**REQUEST FOR TENDER
ORANGUTAN OUTDOOR EXHIBIT CONSTRUCTION
RFT#: TZC T 57-2019-12
ADDENDUM # 2**

Date Issued: 2020 January 15
Project Name: **Toronto Zoo Orangutan Outdoor Exhibits**
To: Ben Knoop
Toronto Zoo
361A Old Finch Avenue
Toronto, ON M1B 5K7
Project Number: 18-1-086
RFT Reference No.: TZC T-57-2019-12 (issued 2019-12-17)

ADD #A002

4
S-832 1:10

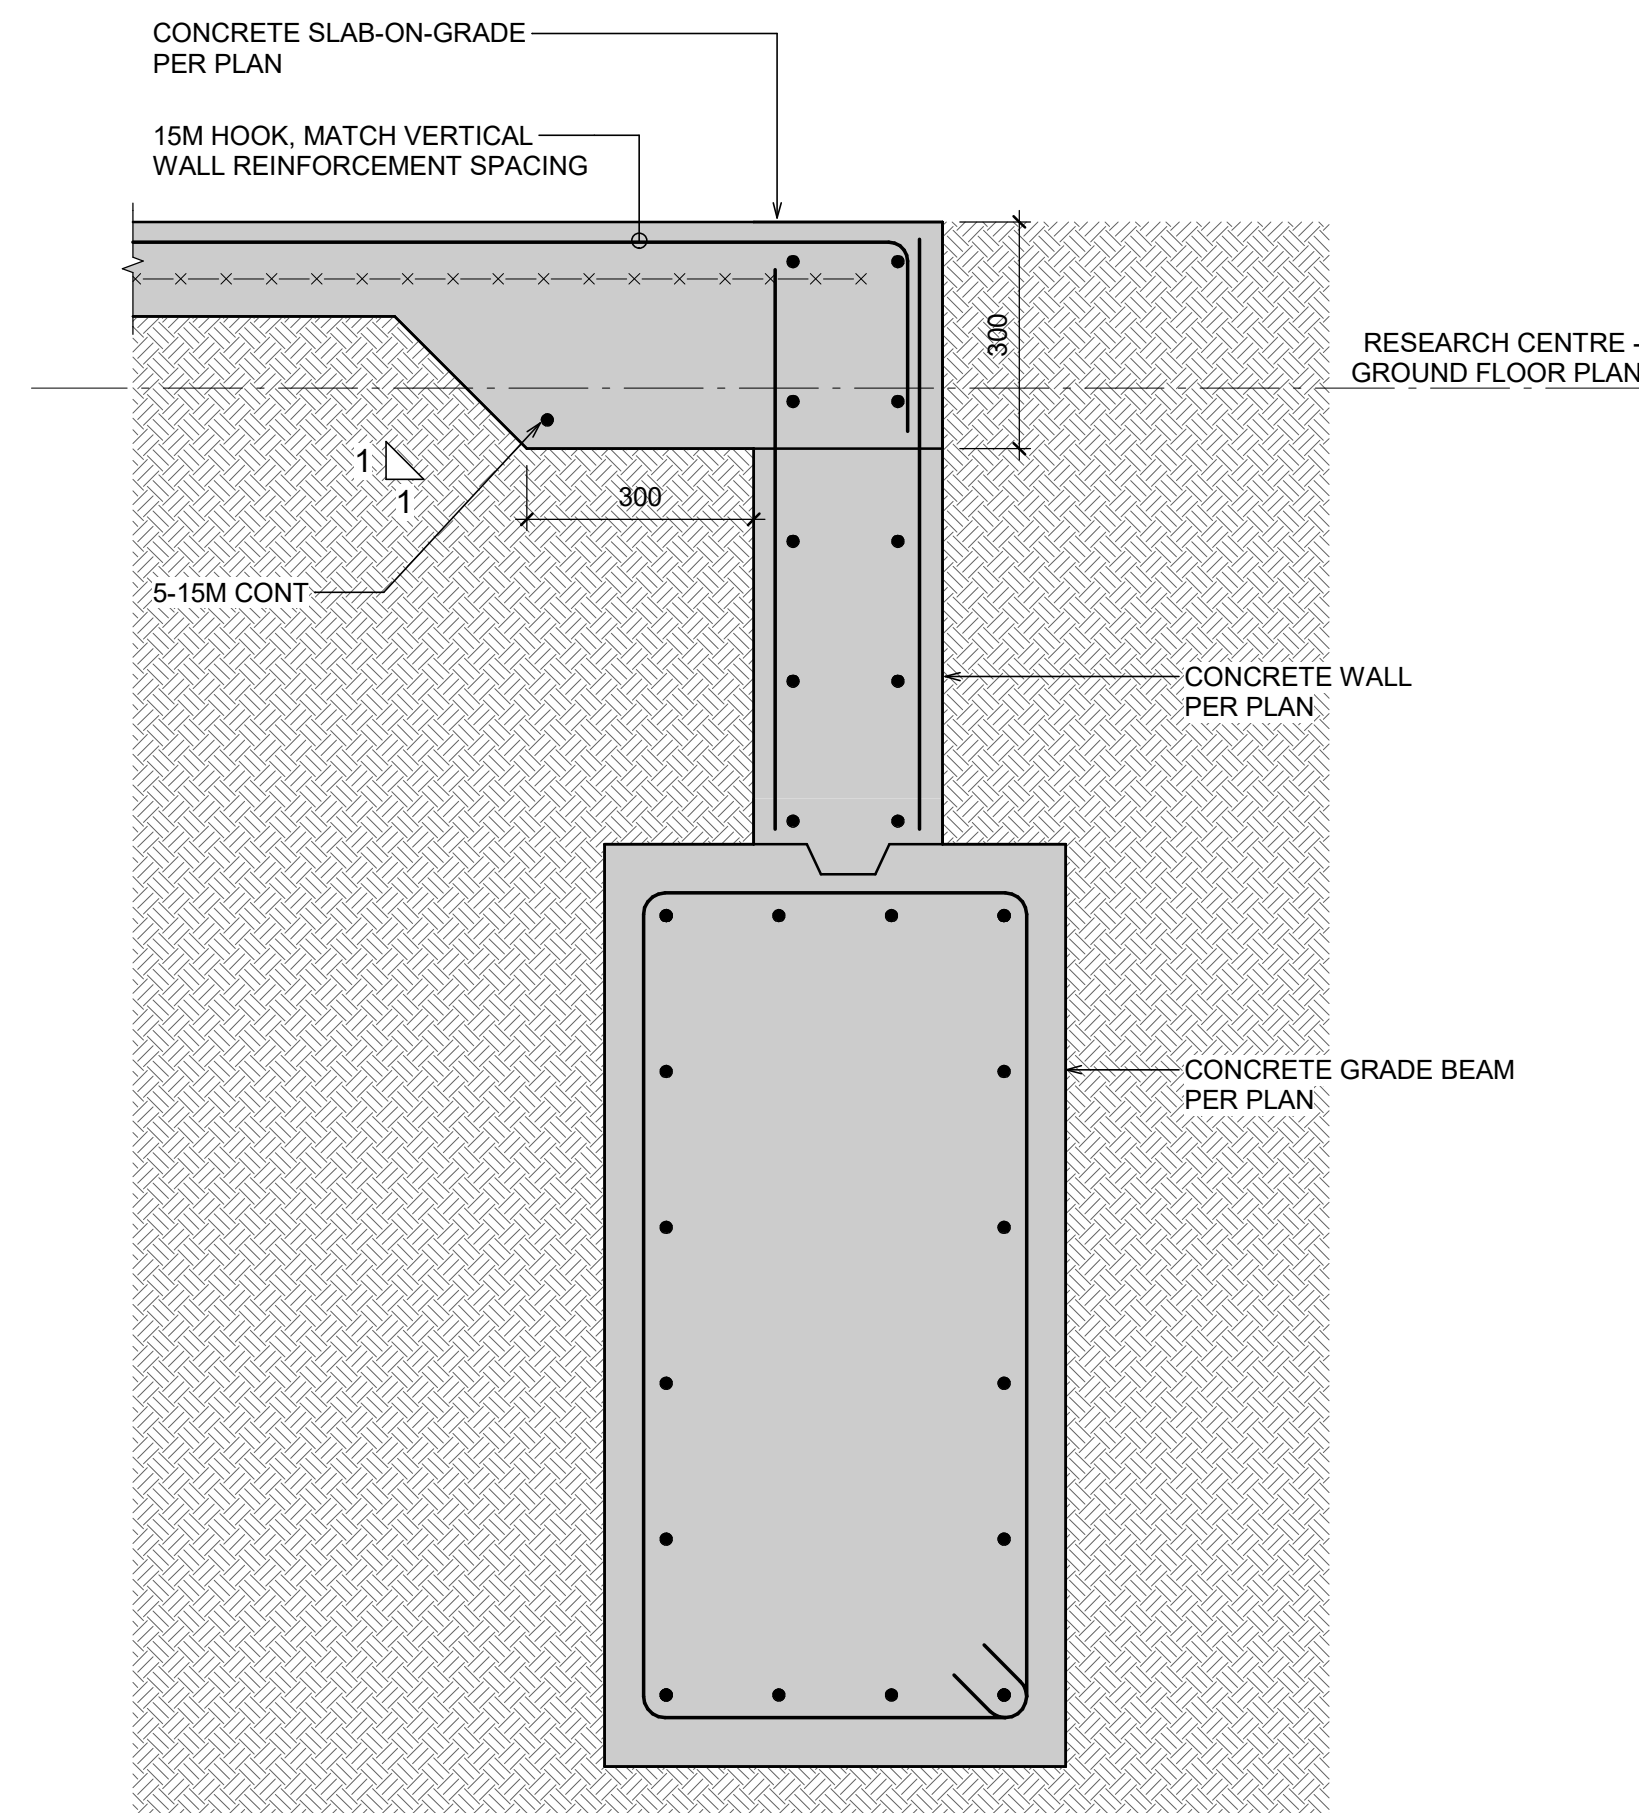
- 4.20. S-832
 - a. Detail 5 modified
- 4.21. S-840
 - a. Braced frame connection forces modified
- 4.22. S-841
 - a. Slab thickened detail added for climbing pipes
